SERVICE INFORMATION

LAND-ROVER PETROL AND DIESEL MODELS

The Rover Company Limited, Solihull,
Warwickshire, England

March, 1972

Fig. 2 Correct location of speedometer cable RH Stg. models

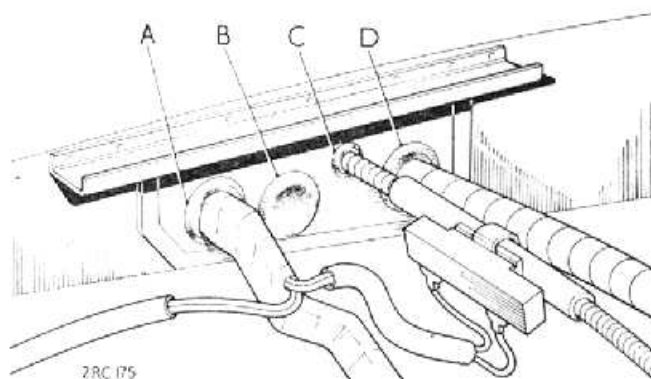
Some early Series III vehicles have the speedometer cable routed through the grommet hole which is normally blanked off. This incorrect assembly forces the cable through a sharp angle and can promote early speedometer inner cable failure.

Service Personnel should familiarise themselves with the correct layout as illustrated and give particular attention to this point when early Series III Land Rovers are inspected.

Fig. 1 Location of bush for 4-wheel drive selector rod

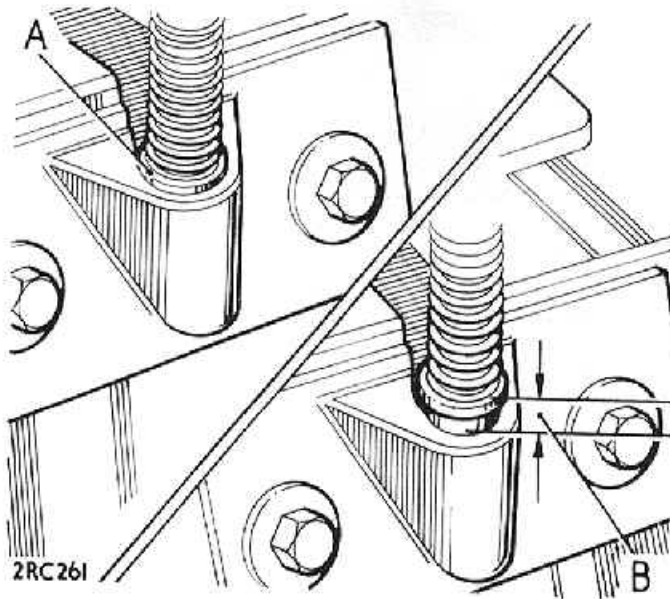
REMARKS: Recent investigations into a complaint of inability to select four wheel drive high range revealed that the selector rod return spring became coil bound. This was caused because the external diameter of the bush was too large, which prevented the bush seating properly in the cover plate.

The bush should fit almost flush with the cover plate, but with incorrect tolerances it may be approximately 50 mm ($\frac{1}{2}$ in.) too high.

Should this condition be encountered we recommend that the cover plate be removed and the hole enlarged to accommodate the bush.

Fig. 1 Correct location of solenoid feed wire

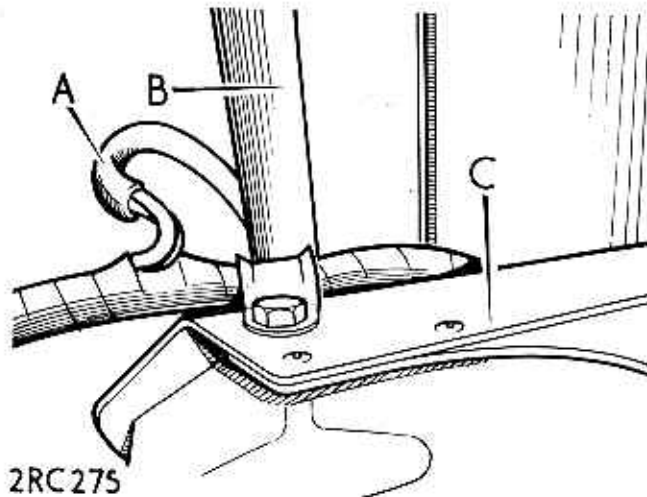
MODIFICATION: Introduction of modified main harness to prevent a foul condition between air cleaner, harness and wing valance.

Should the solenoid feed wire be badly chafed, it should be replaced with the modified main harness assembly.

**Fig. 2 Identification of ignition lead**

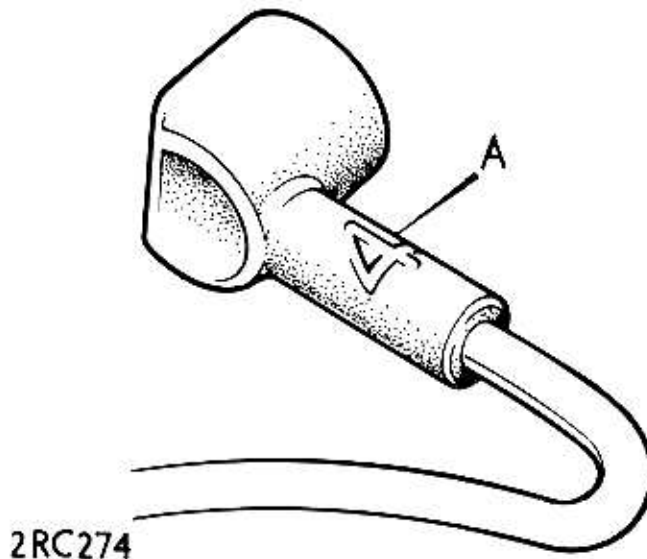
If this condition is detected or brought to your attention by an owner, on vehicles sold during the last 12 months, then the coil to ignition lead must be changed for the modified type, which has a moulding number stamped on the right angled coil boot. The earlier type has no moulding number.

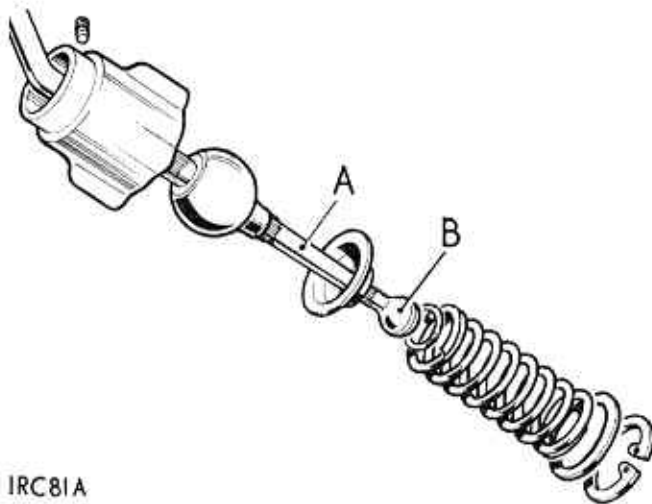
Over a period of time there have been instances of failure of the Polyurethane material used for the ball end attached to the gear lever on Series IIA vehicles.

Since last November this material, which is also used currently on the Series III, has been subjected to additional laboratory tests to ensure its consistency with our specification.

Any future recurrence of this problem should be satisfactorily remedied by fitting a replacement gear lever.

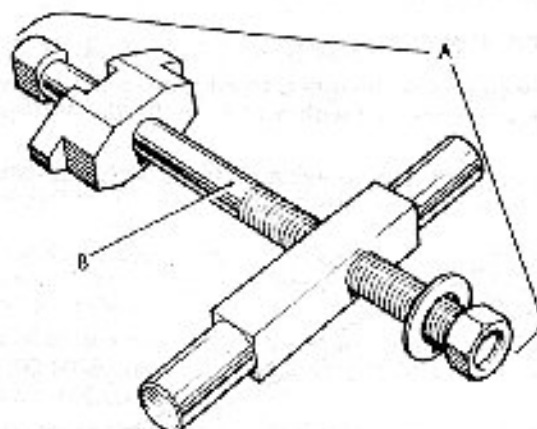
MODIFICATION: Introduction of a lengthened centre bolt for the differential pinion head bearing removal tool; the associated press block has also been modified to give improved contact with the head bearing. The centre bolt length has been increased from 180 mm (7 in.) to 230 mm (9 in.); press block diameter increased from 69 mm (2.7 in.) to 77 mm (3.0 in.).

Lengthening the centre bolt has resulted in a tool number change from 262757 (which remains suitable for early models) to 262757A which is suitable for both early and late models. The longer centre bolt is available separately under Part No. 262757A detail 3 to enable holders to modify their original tool Part No. 262757 which is then suitable for both early and late models.

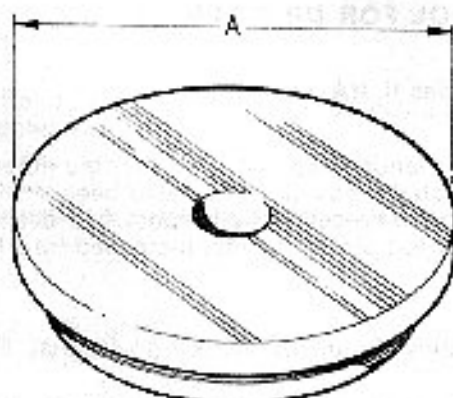
In conjunction with the above modification, the opportunity has been taken to provide a new press block which gives a greater contact area with the pinion bearing cup. The new press block Part No. 262757-1 replaces the earlier press block Part No. 262758 for the following models:

**Fig. 2 Clutch release bearing and sleeve assembly**A—'Ferrobestos' sleeve
B—Sealed bearing
C—'Loctite' bonded joint

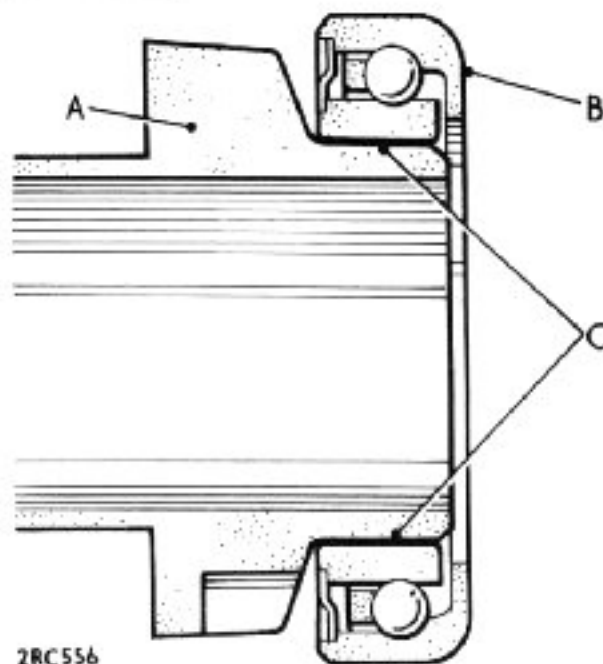
The above modification has been introduced to reduce the possibility of the clutch release sleeve becoming seized on the front cover extension during arduous driving conditions and to improve the bearing lubrication.

The assembly comprises a sleeve manufactured from 'Ferrobestos' and a new release bearing which is packed with grease and sealed. These are bonded together by Loctite high strength retaining compound.

Fig. 1 Inlet manifold butterfly valve

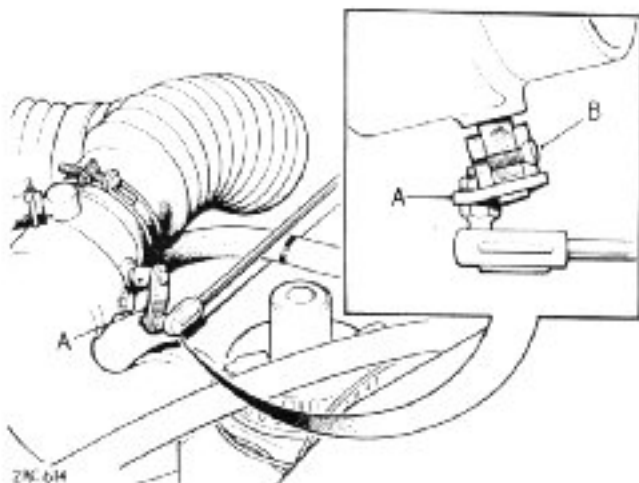
If this condition is present on a vehicle, it can cause either a loss of vacuum or excessive smoke to be emitted from the exhaust. Should Distributor or Dealer personnel come across this problem they are advised to first check the positioning and tightness of the clamp screw. If the component is found to be loose it is recommended 'Studlock' or 'Loctite' is applied and the screw re-tightened.

Production Department, as an interim measure, from April, 1972, have been applying 'Studlock' on the screw. To overcome this possible condition permanently, however, it is anticipated that a re-design of the particular area concerned will be carried out.

Fig. 2 Distance piece for inner hub bearing

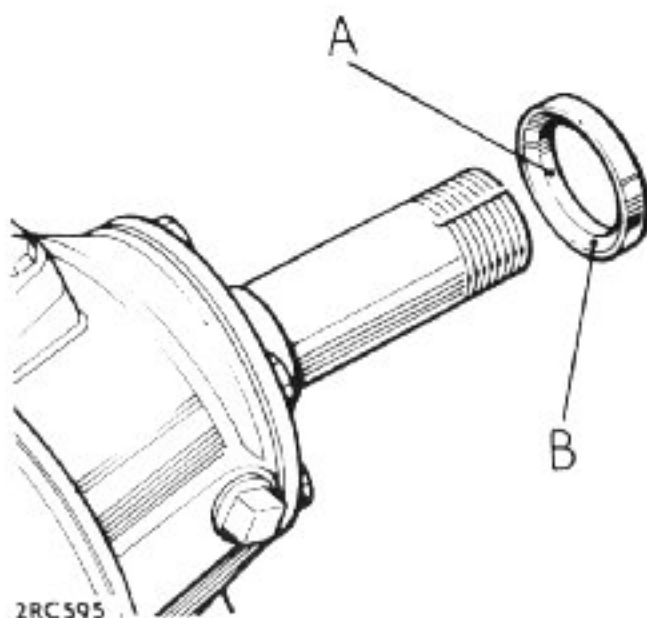
MODIFICATION: Introduction of mild steel distance piece to eliminate oil leaks arising from previous sintered iron type.

NOTE: Because of the material change the mild steel distance piece cannot be removed in the same way as the sintered iron type.

In this case, it is recommended that, by exercising reasonable care the distance piece can be partially cut through with a sharp chisel to loosen it, when it can be gently prised off.
